RE: Submission of Legal Counsel Comments Regarding Upton Apartments 40B Application

RE: Initial Review of 40B Application – 47 Main Street

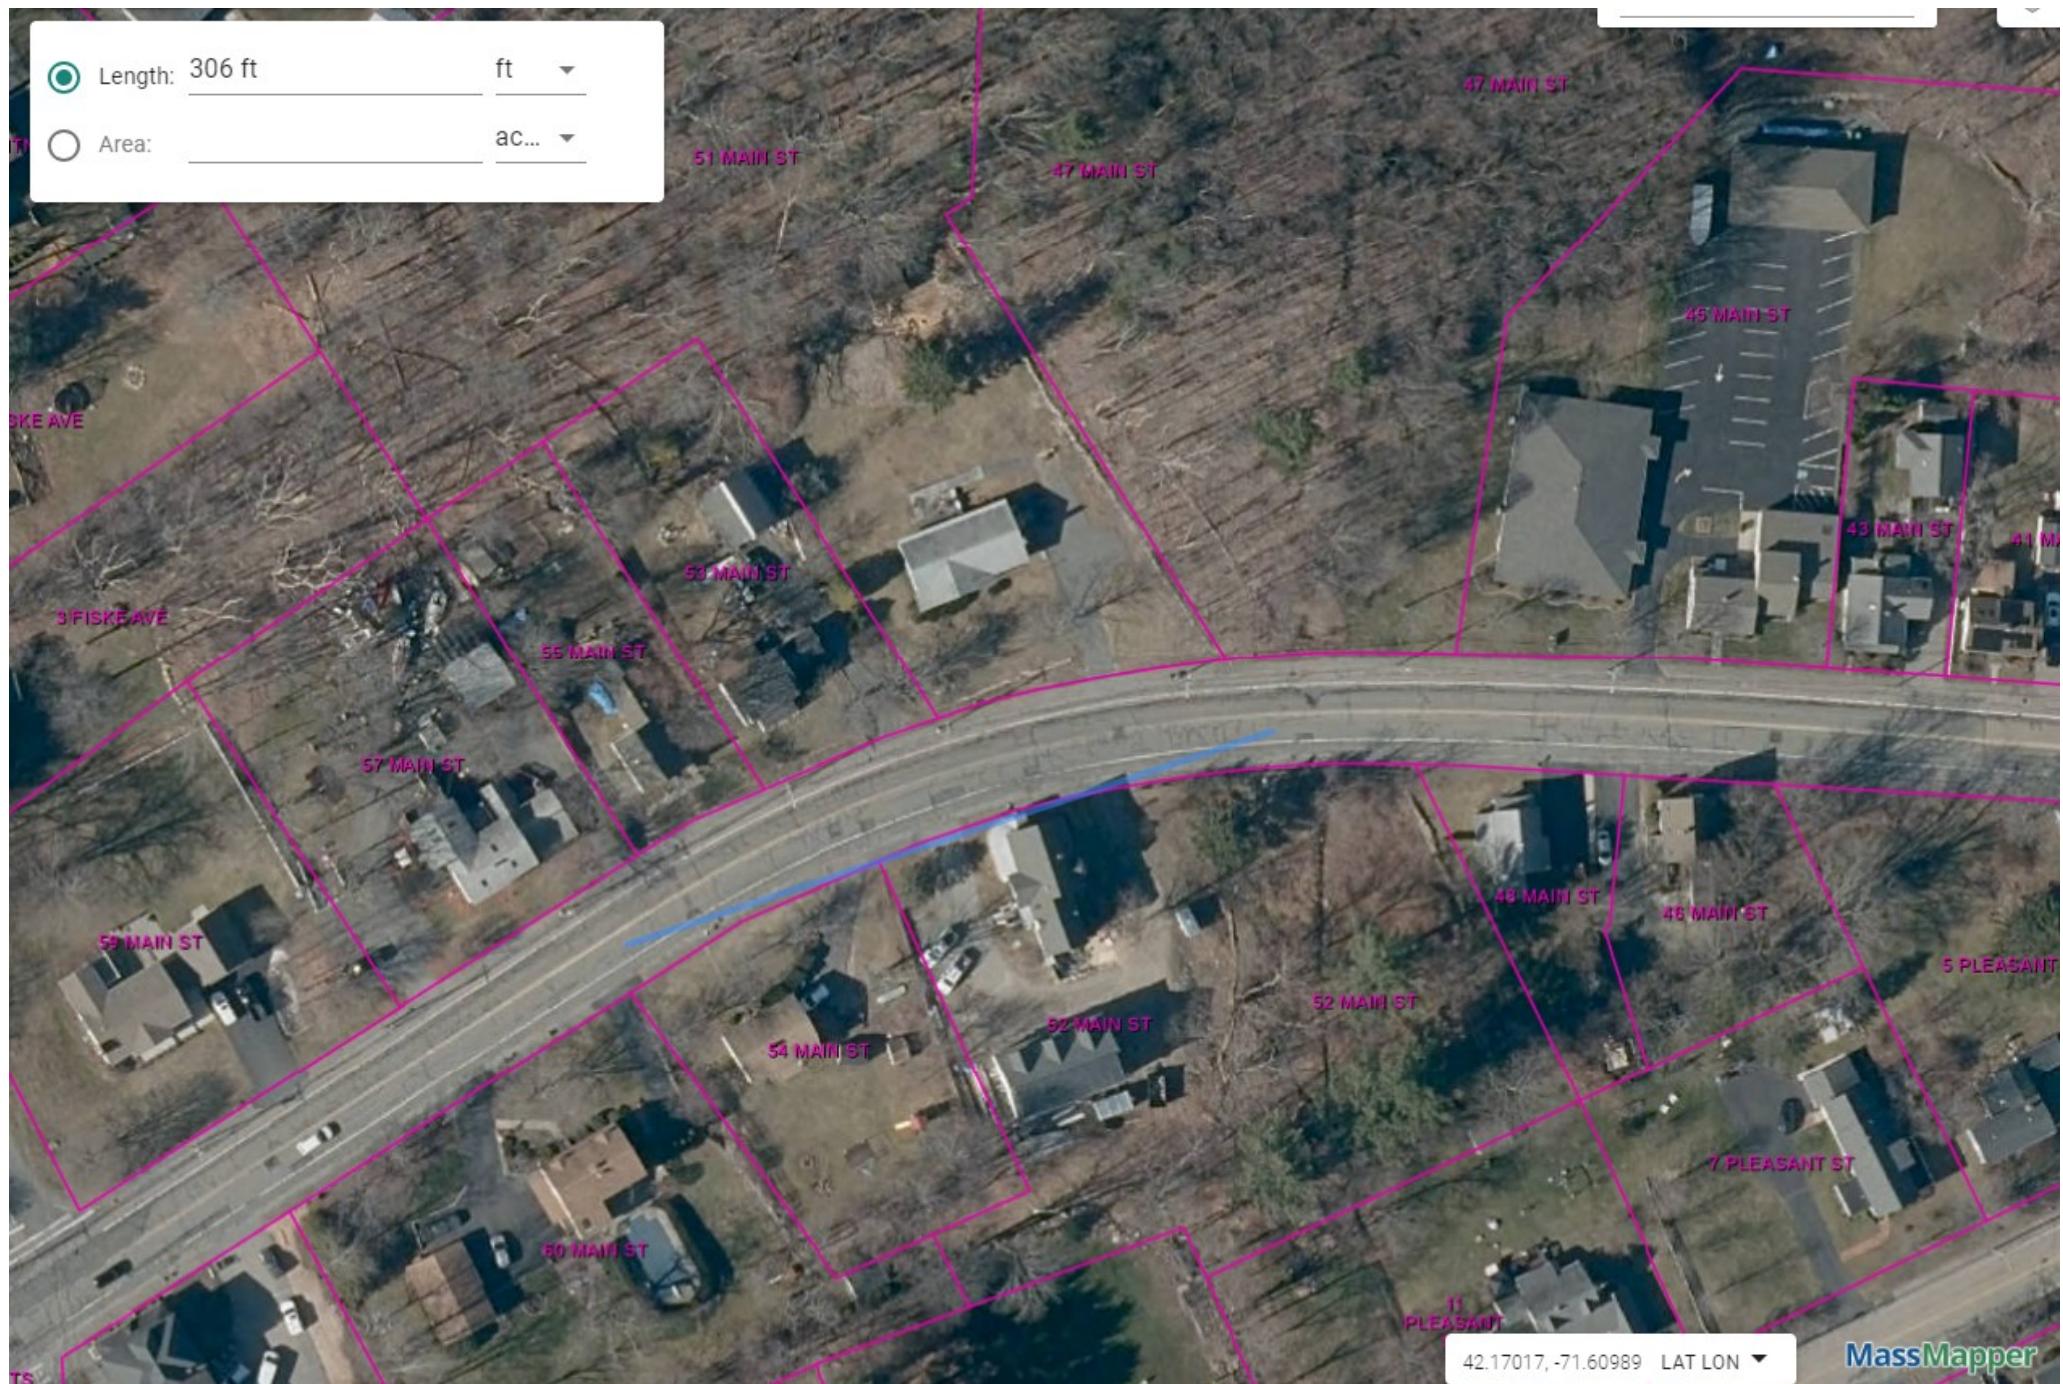
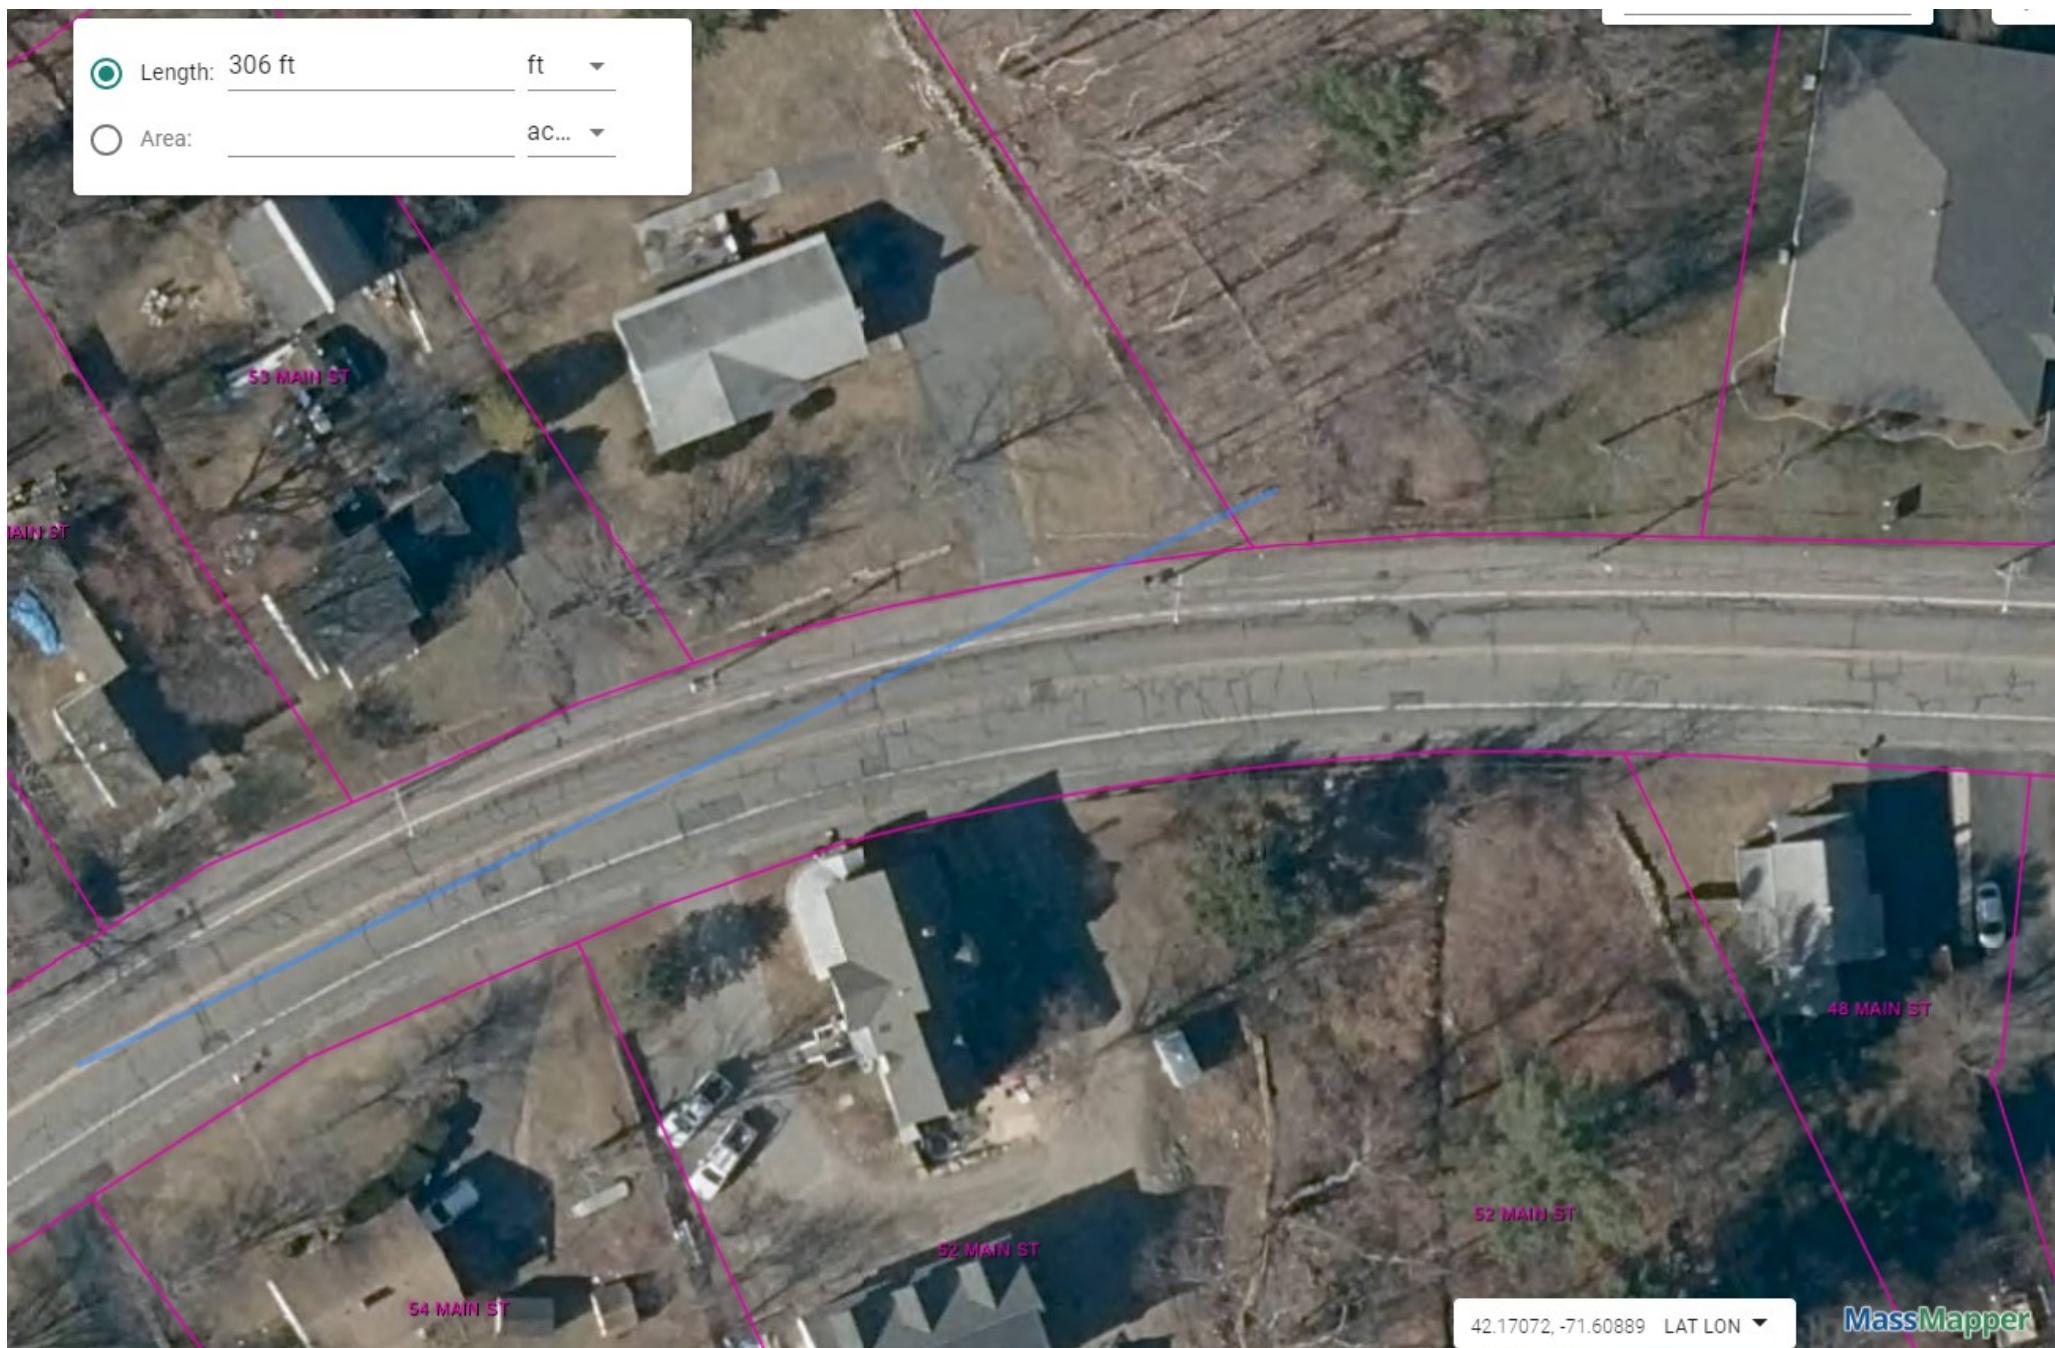
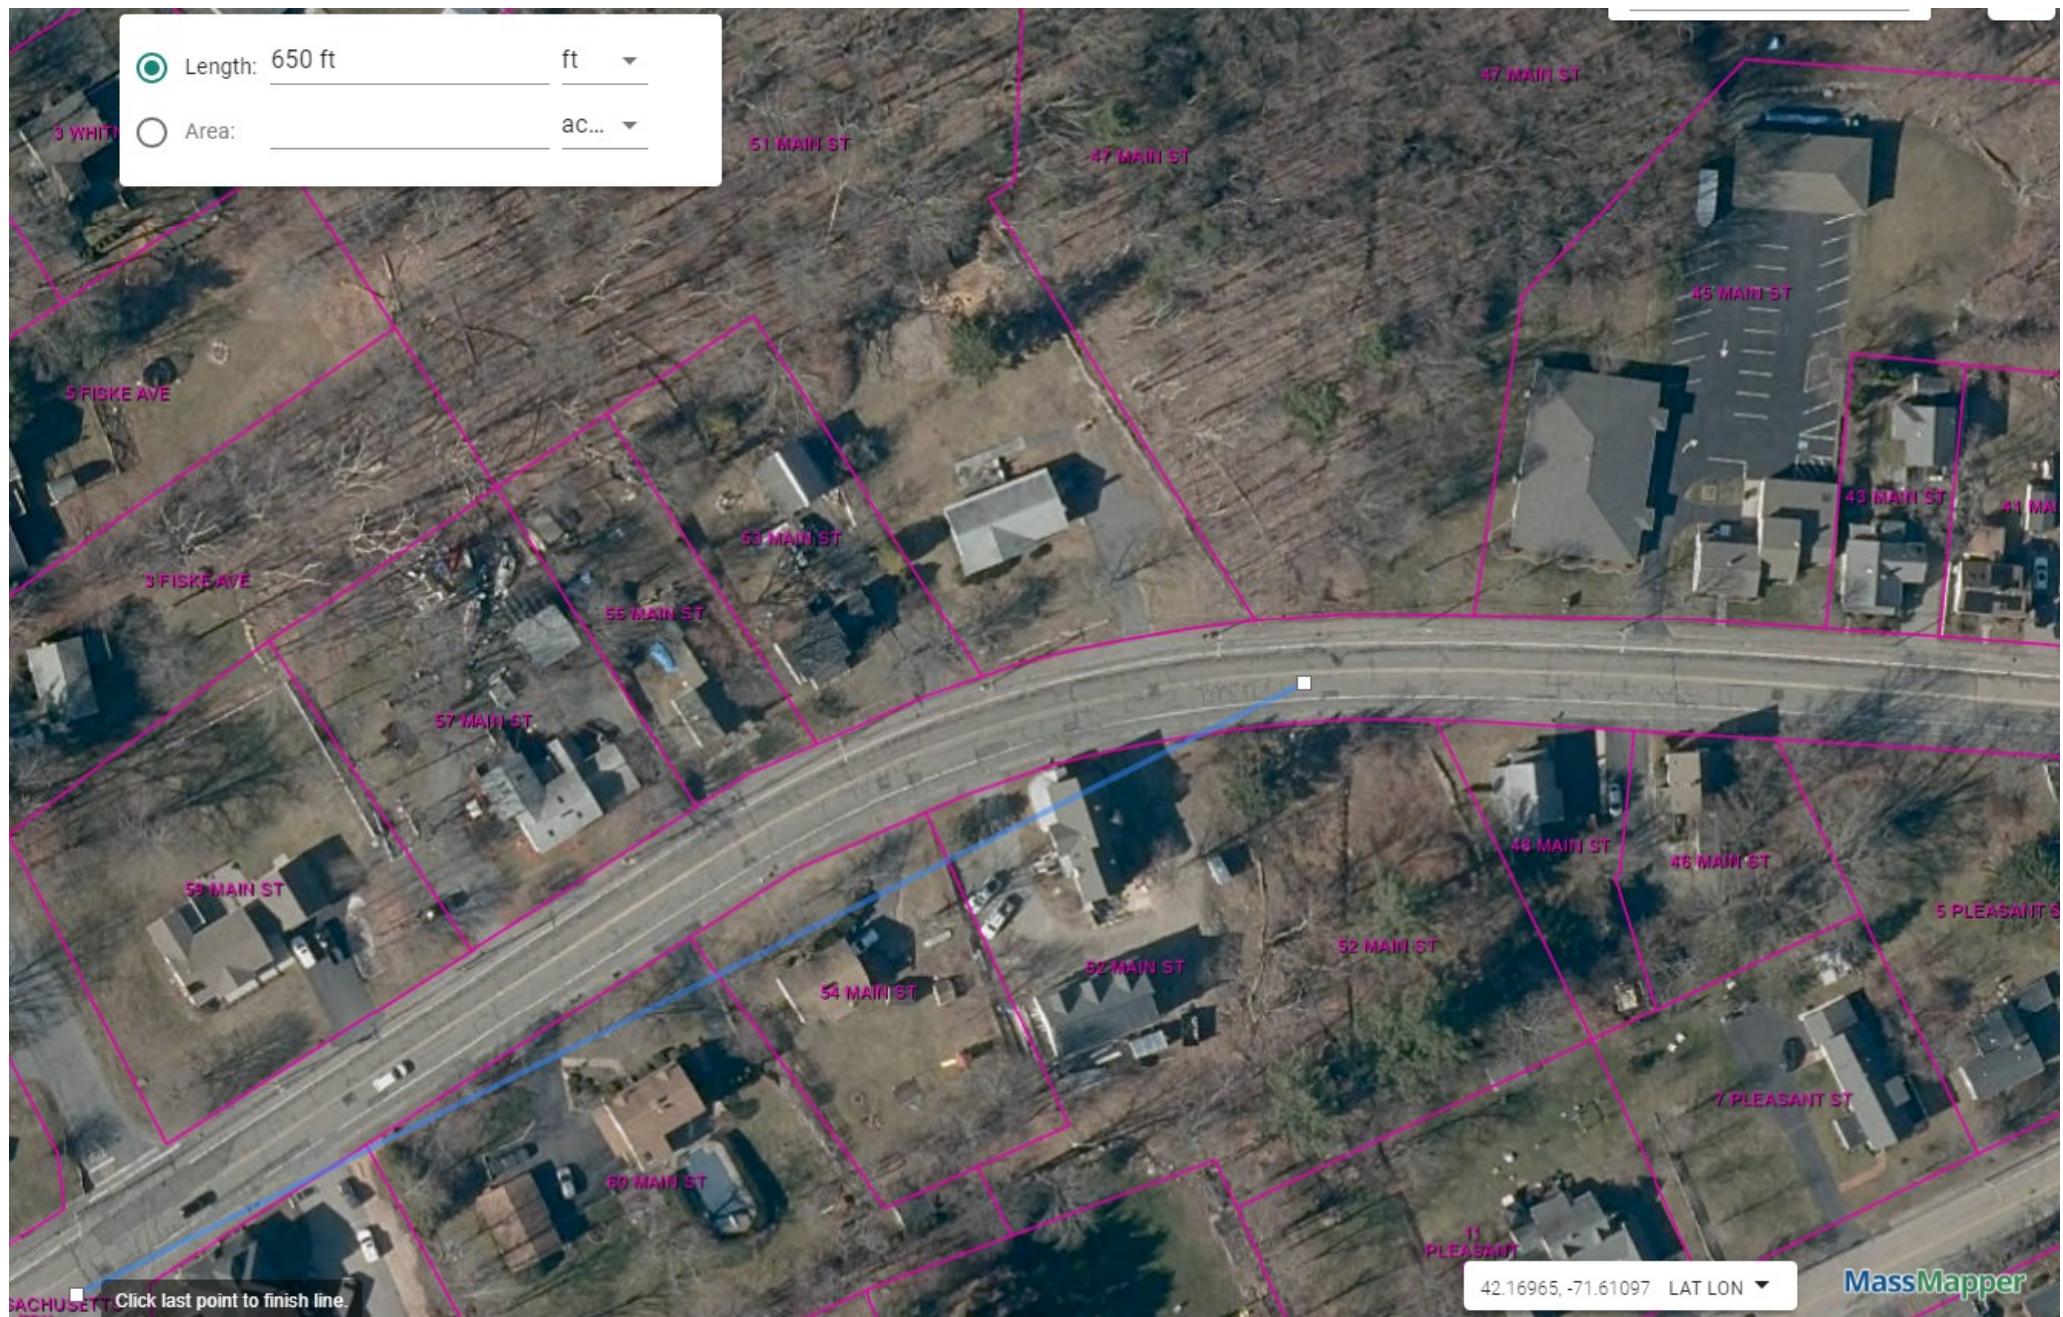
The Applicant states that based on the recorded travel speeds in Route 140 under existing conditions, the minimum SSD and ISD necessary for this Project intersection is 305 feet in both directions. Assuming this to be correct, I question the Applicant's conclusion that it has 650 feet of SSD and ISD in either direction. Route 140 curves to the south to the west of the proposed intersection, and this has the effect of blocking sight distances in the westerly direction. Attached are several figures I prepared using the MassGIS website and measuring tools, indicating that both the SSD and ISD sight lines would cross over private property if they are at a length of 305 feet. SSD of 650 feet is **not** achieved west of the intersection, due to the curvature of the road, based on my basic assessment.

Concerning ISD, AASHTO guidelines specify that in making this calculation, the sight line is measured from a location **14.5 feet back** from the edge of the roadway, and 3.5 feet above the driveway grade, representing the position of the driver's eye sitting in a car that has approached, but not yet entered, the intersecting street (here, Route 140). From a distance 14.5 feet back from the edge of the road, the sight line crosses over the private property at 51 Main Street, and likely crosses over 45 Main Street to the east. See, **Figure 1** below. Absent a legally-enforceable agreement such as a license or easement, the Applicant has no way of preventing that abutting owner from installing a tree, fence, or other view obstruction on its own property. Surprisingly, the ZBA's peer reviewer, Stantec, accepted the Applicant's conclusions of 650 feet.
